Name: Morné de Jager
Cell: 082 565 4059
E-mail: morne@menco.co.za
Date: 14 June 2019
Ref: Castle WEF

SPECIALIST STUDY: NOISE IMPACT ASSESSMENT: PROPOSED CASTLE WIND ENERGY FACILITY EAST OF DE AAR: CHANGE OF WIND TURBINE SPECIFICATIONS

Figure 1: Locations of wind turbines compared evaluated

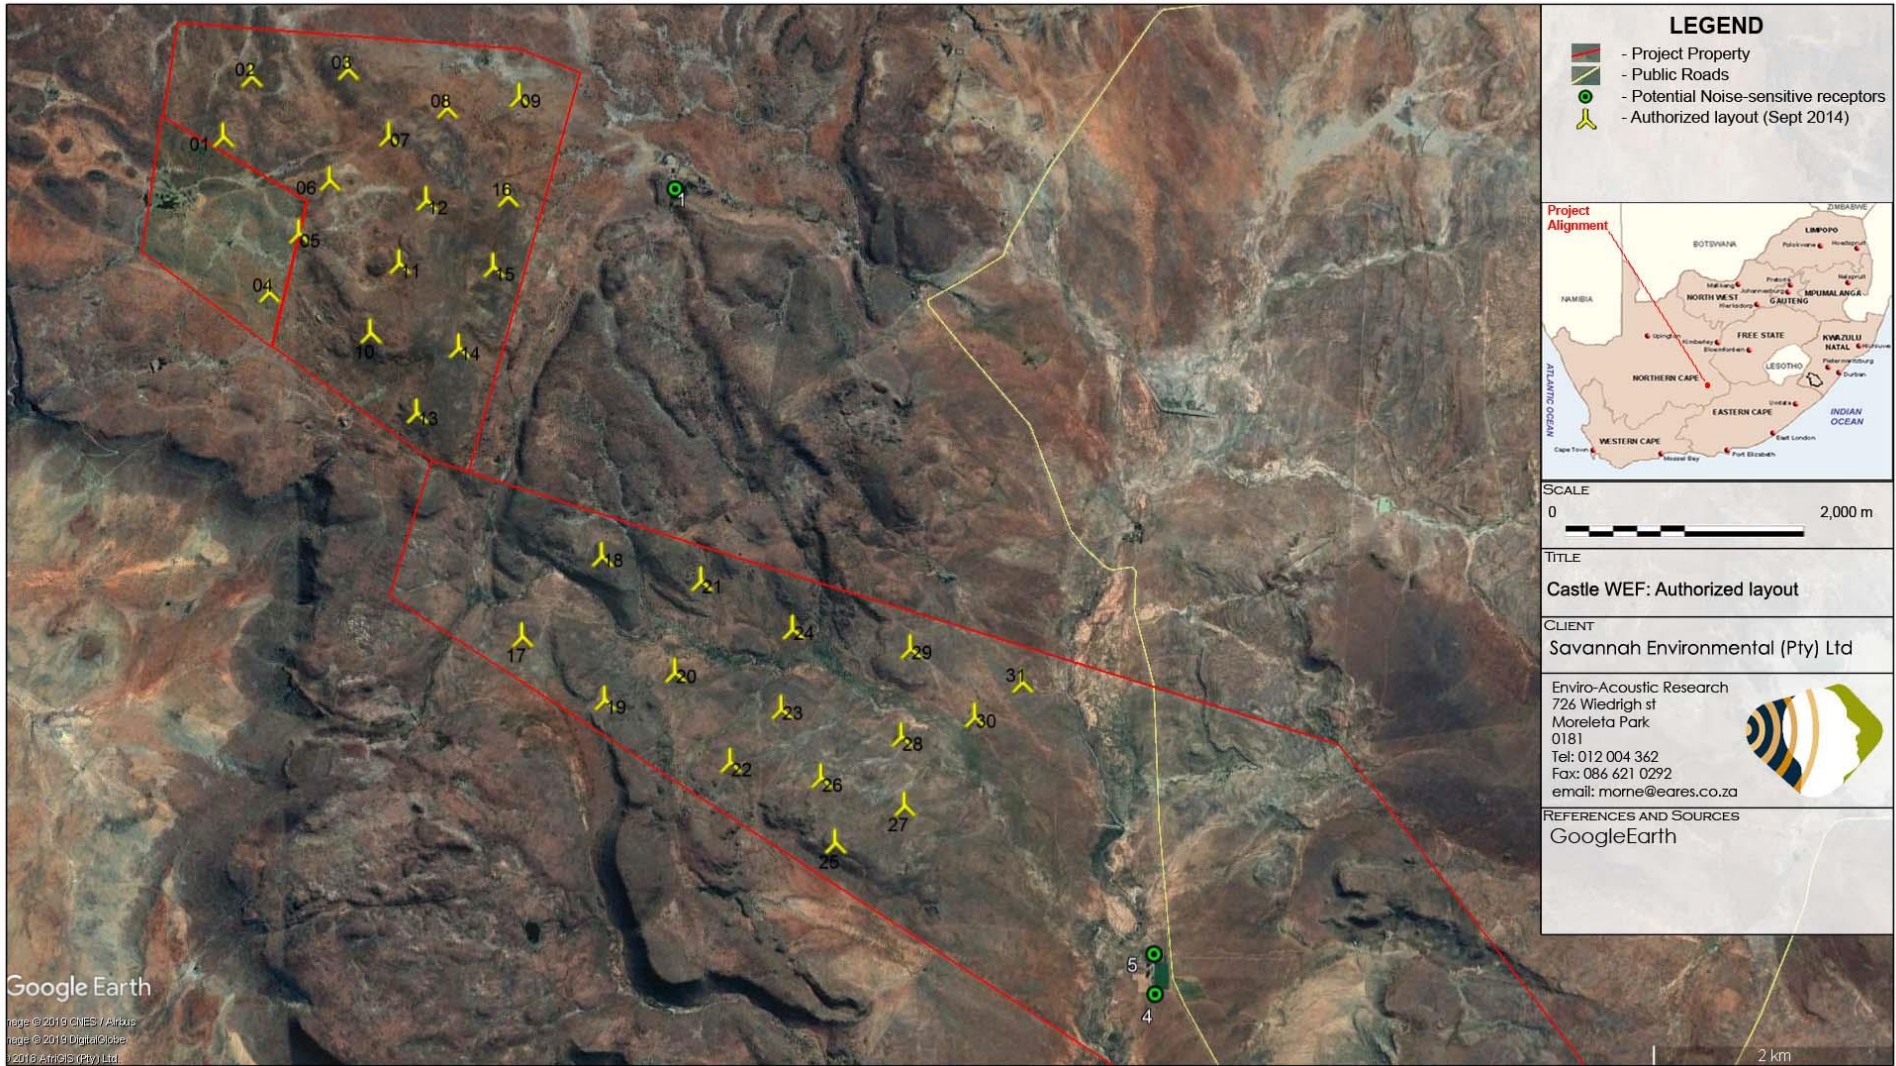
All of the proposed wind turbines are further than 1,000m from any potential noise-sensitive receptors and even with the higher potential sound power emission level (worst-case of 109 dBA), the maximum projected noise level will be less than 38 dBA at the closest NSD.

Considering the location of the wind turbines and the potential noise impact, it is my opinion that the change will not increase the significance of the noise impact. A full noise impact assessment with

new modeling will not be required and the findings and recommendations as contained in the previous document will still be valid. Therefore, from a noise perspective these changes are acceptable.
